## Addendum 3 – Regulation No. 4

### Revision 3 - Corrigendum 1

Corrigendum 1 to Revision 3 of the Regulation (*Erratum by the secretariat*)

### **Uniform provisions concerning the approval of devices for the illumination of rear registration plates of power-driven vehicles and their trailers**

Annex 4,

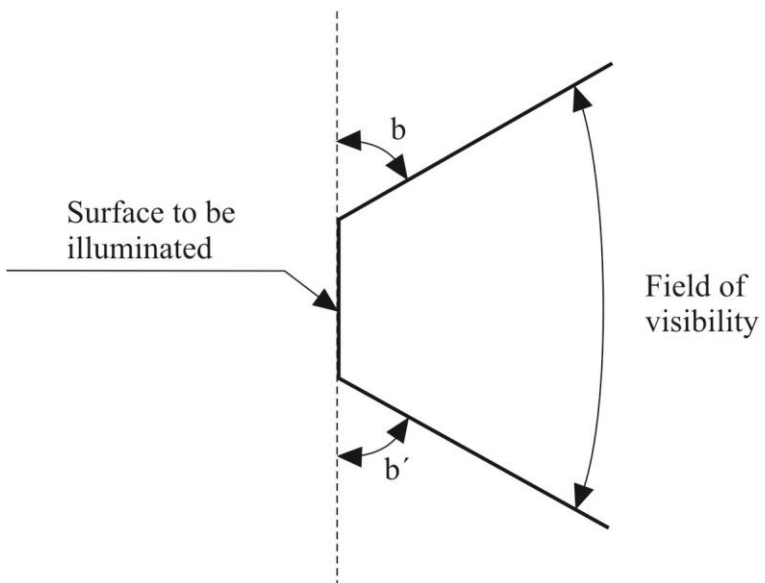
The figure, correct to read:

**a and a' should be  $\leq 85^\circ$**

**b and b' should be  $\leq 60^\circ$**
